Central High School Walk Audit of Central Ave./MD 214 Debrief

Cabin Branch Road (county) connecting school to MD 214

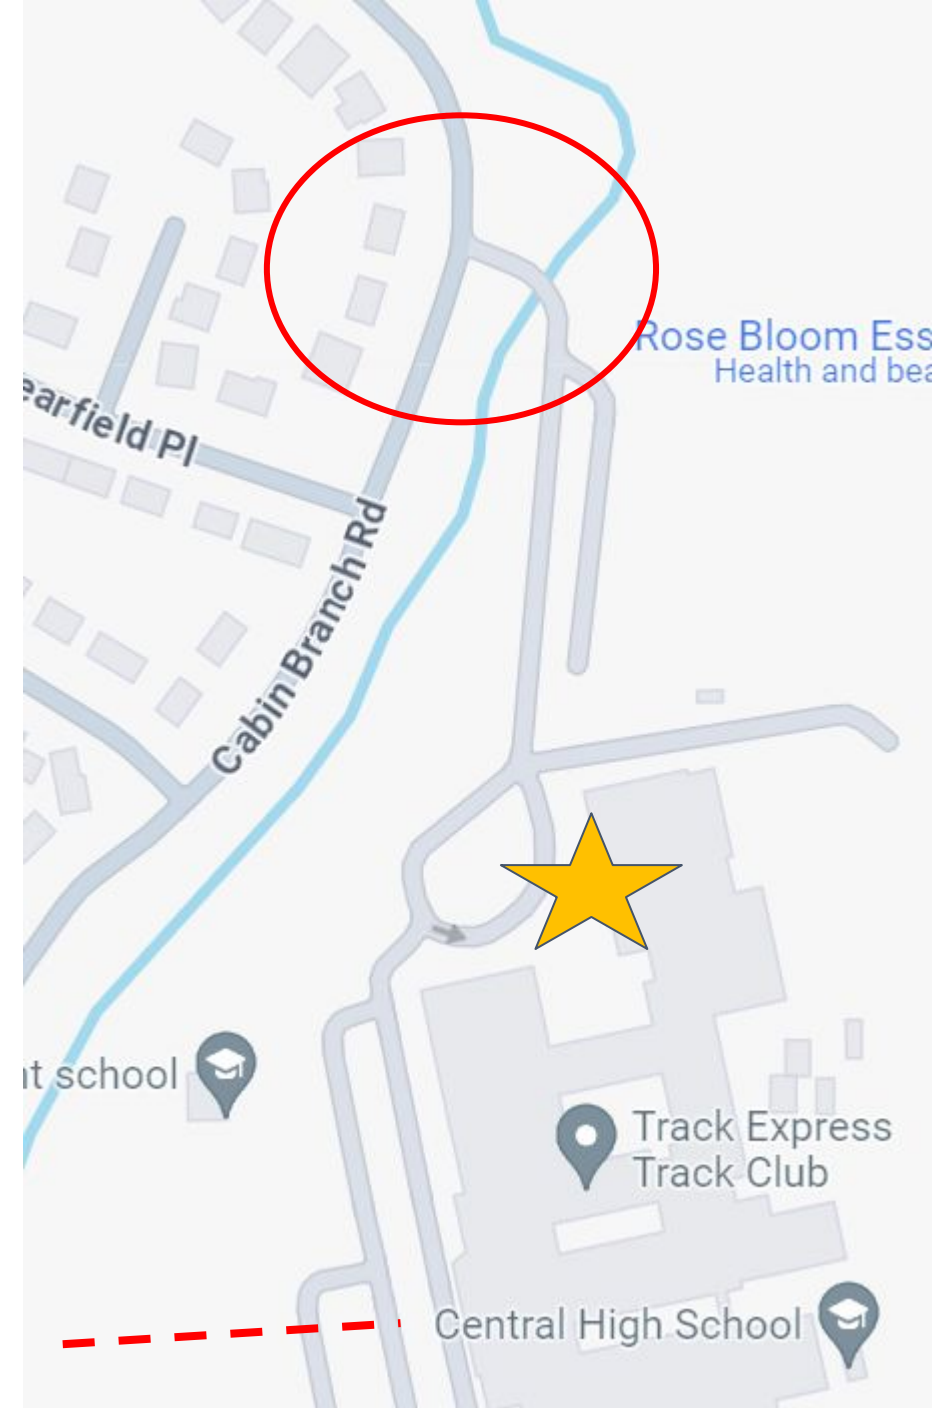
- Missing sidewalk on east
- No crosswalk from west sidewalk to school drive
- Overly wide road
- No buffer on west sidewalk
- Path connections from West & South

MD 214 & Cabin Branch Rd Intersection

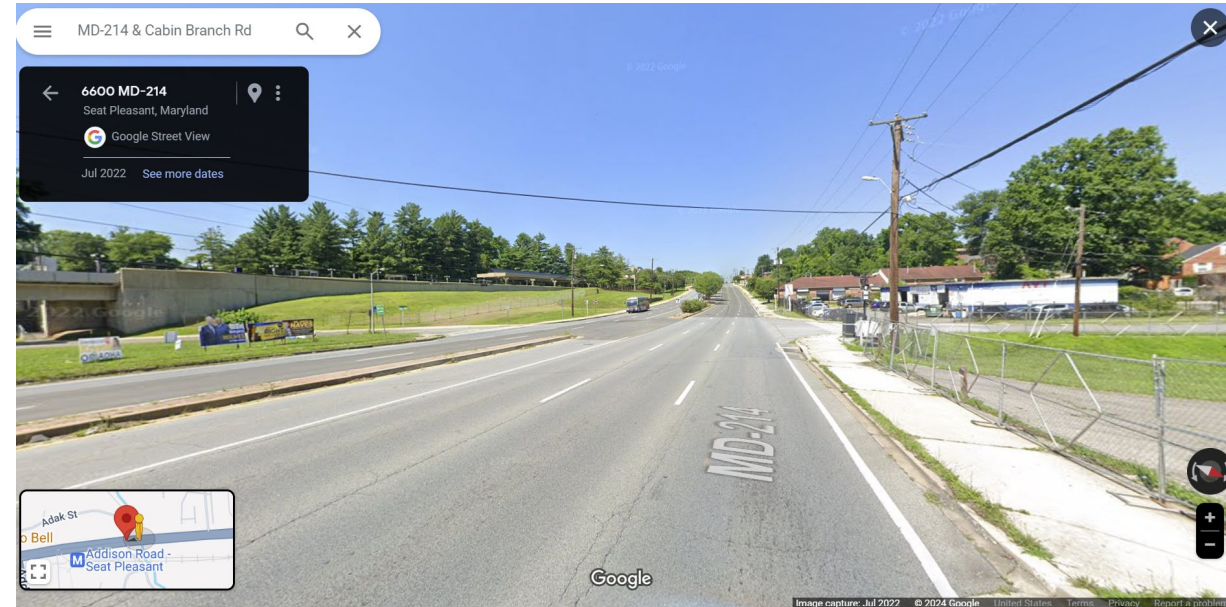
- No crosswalk
- No signal (for peds, left turns, bus stops)
- Overly wide, high speeds
- No bus stop amenities
- Large corner radii
- Long crossing distance

Central Avenue

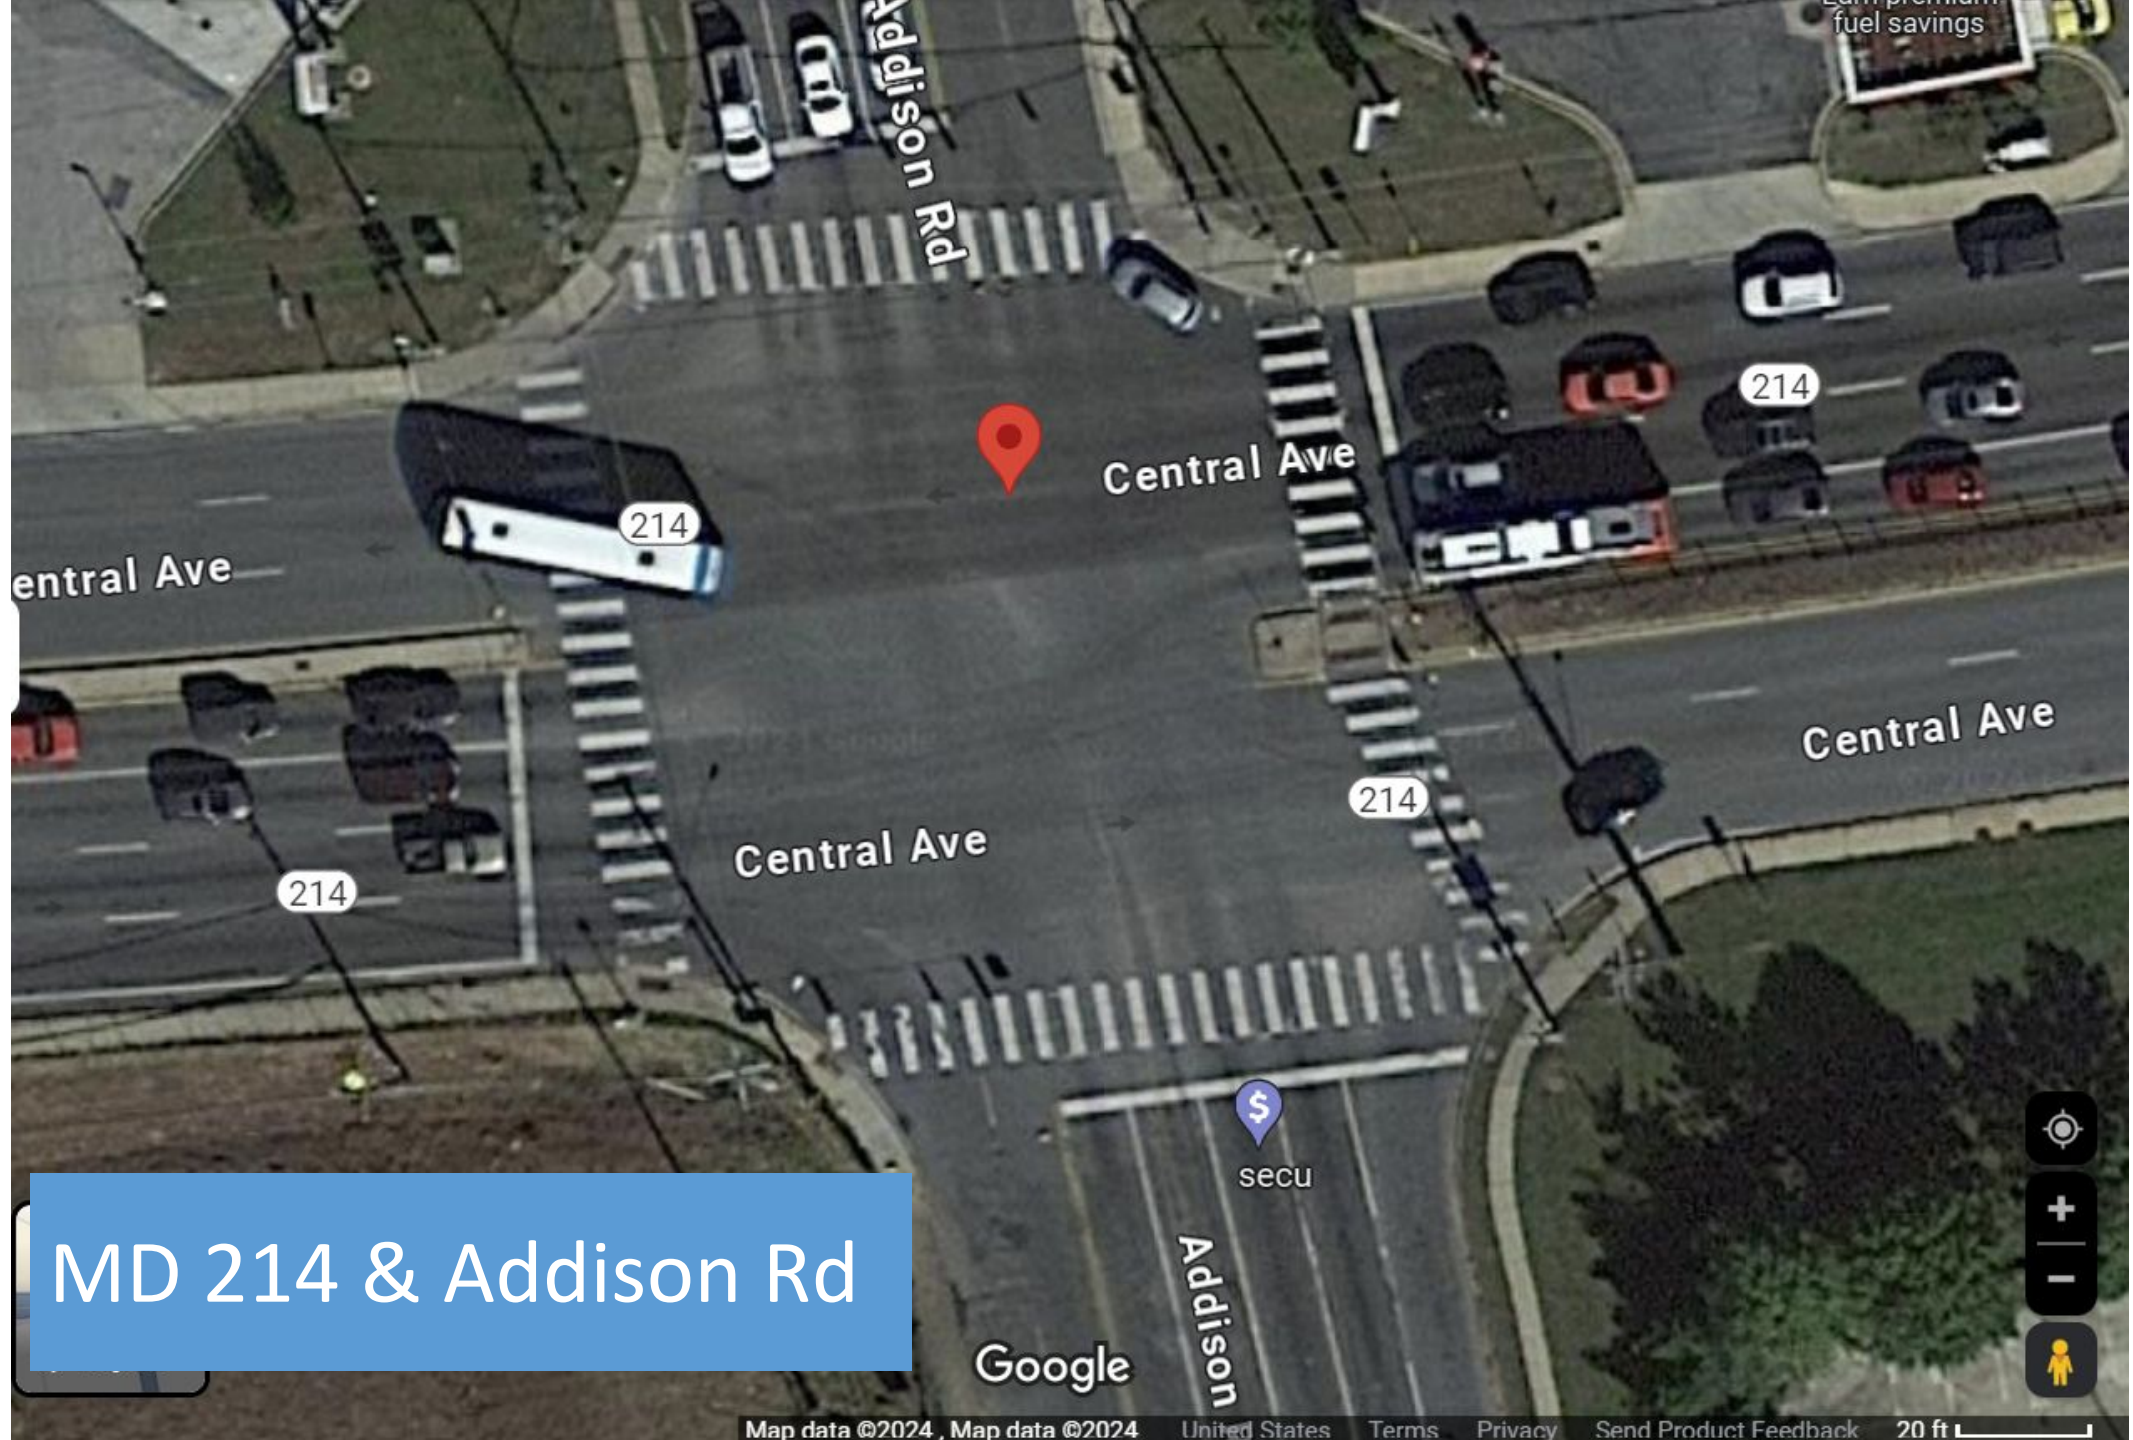
- Narrow sidewalks
- No/small buffer
- Multiple driveway aprons

- Narrow sidewalks
- Too close to cars
- Driving fast
